Title: Architectural and Engineering Services for the Embassy of Canada to Czech Republic, in Prague

Solicitation Number: 24-248401

Questions & Answers # 1

3. Attic Space 2nd Floor existing residence entrance (room is currently divided by these pieces of furniture)

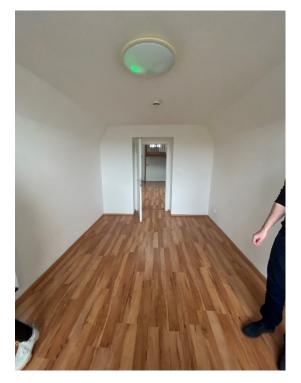
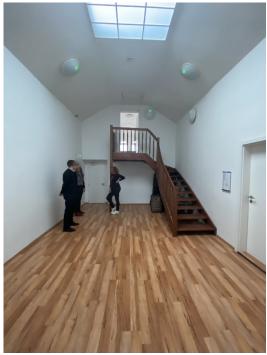
- Q4. "Will you provide pictures of the roof and attic space?"
- A4. Please see attached pictures below.
- **Q5.** "Can you provide more information so that we can better select our projects for the mandatory criteria?"
